Appendix G: RFLMA Contact Records

RFLMA contact records issued during 2011 are included in this appendix.

ROCKY FLATS SITE REGULATORY CONTACT RECORD

Purpose: Replace Mound Site Plume Treatment System (MSPTS) media and maintain/repair discharge gallery.

Figure 2. PLF Dam Breach Construction

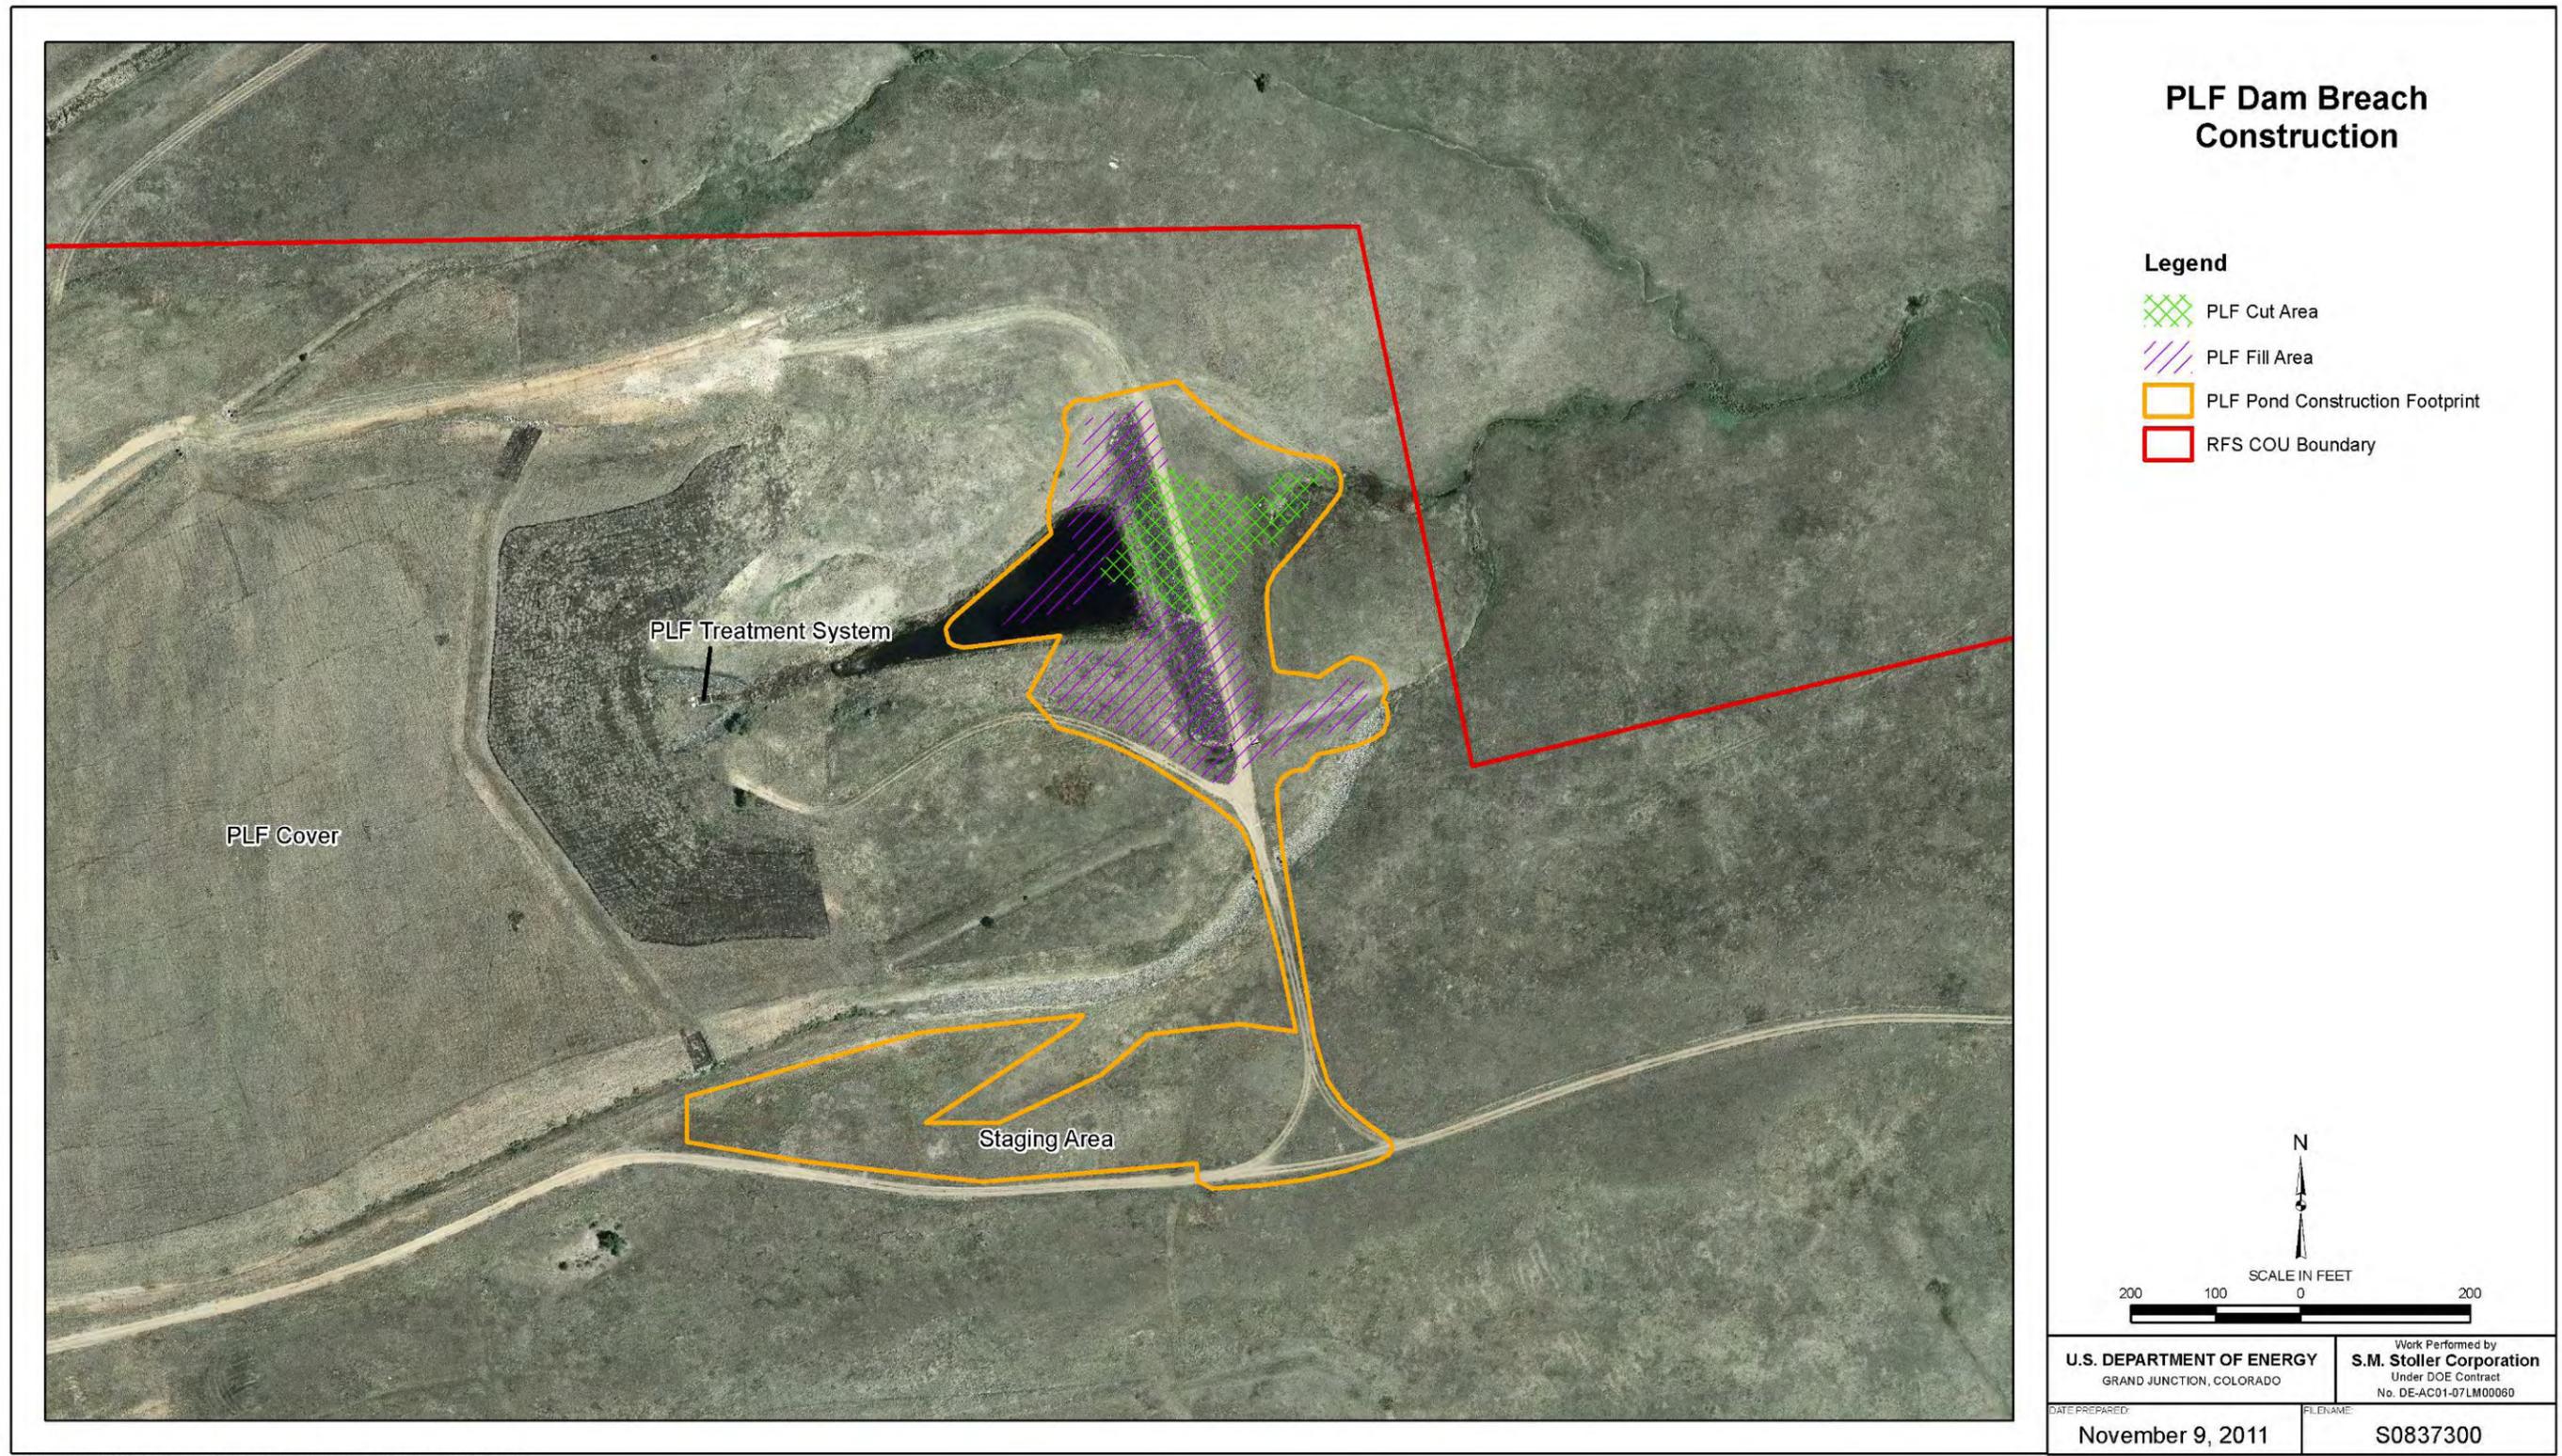
Figures 1 through 5 show the location and the lateral and vertical extent of the excavation. The material excavated for the cut areas will be placed in the fill areas as shown in Figures 1 and 2.

Resolution: Carl Spreng, CDPHE, approved the soil disturbance and excavation work described in the Soil Disturbance Review Plan.

Figure 1. Sampling Location Map

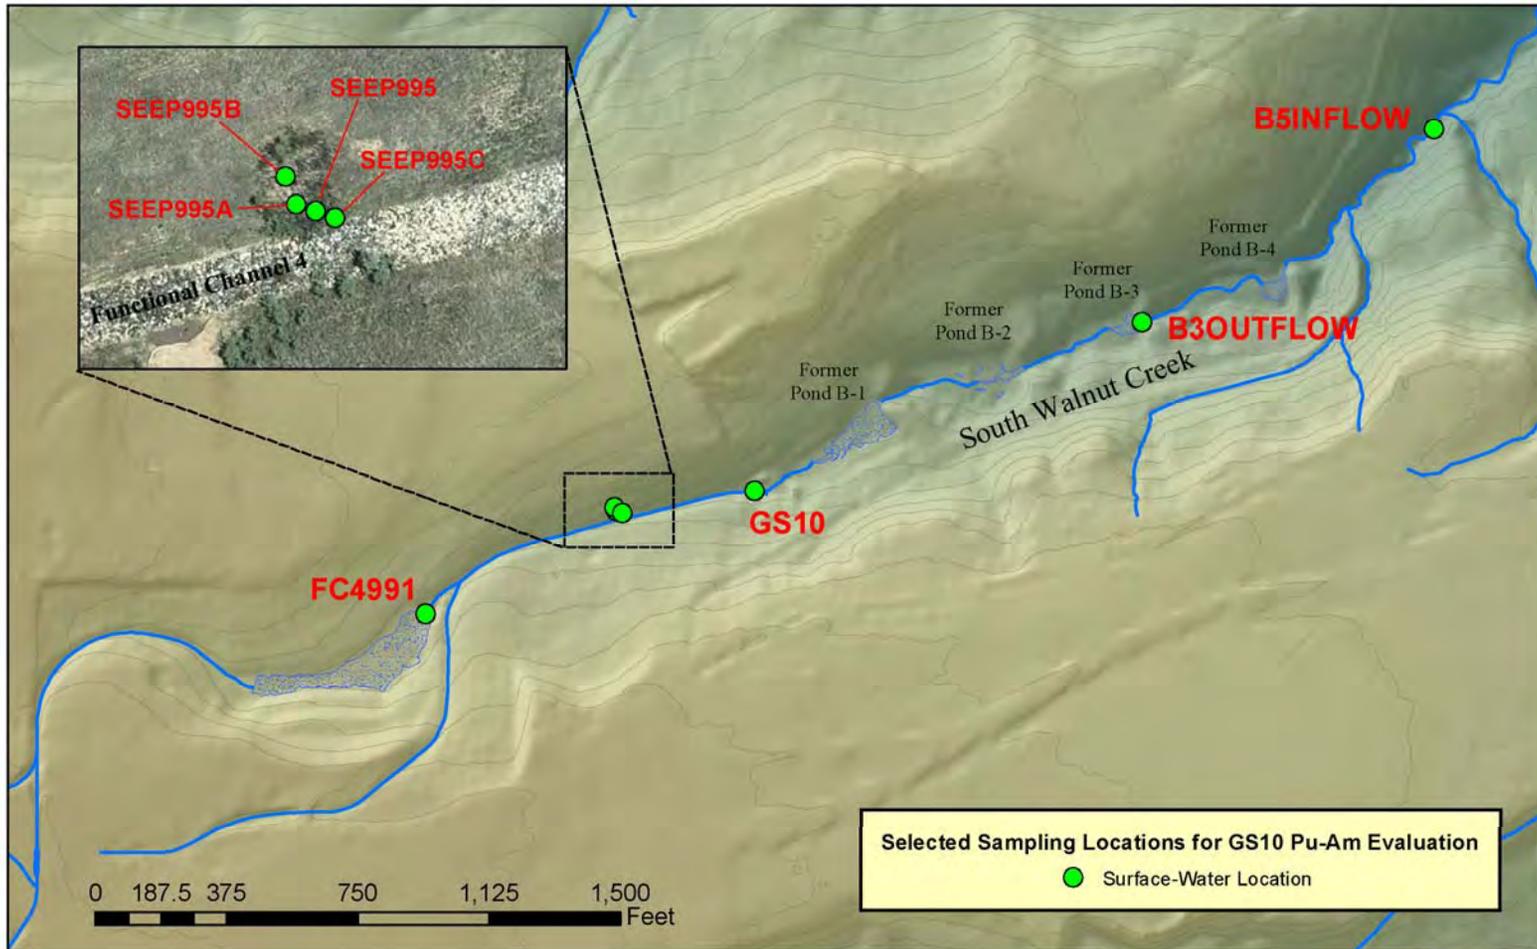
This Contact Record describes the plan and schedule to address the reportable condition. Figure 1 shows the sampling locations related to the evaluation. The plan and schedule for evaluation and the status of actions related to the plan are described below:

The RFLMA Parties will review the analytical results of the sampling described above and consult on whether any additional evaluation monitoring or any mitigating actions are needed. This evaluation plan and schedule to address the reportable condition may be modified based on the outcome of RFLMA Party consultation related to the evaluation.
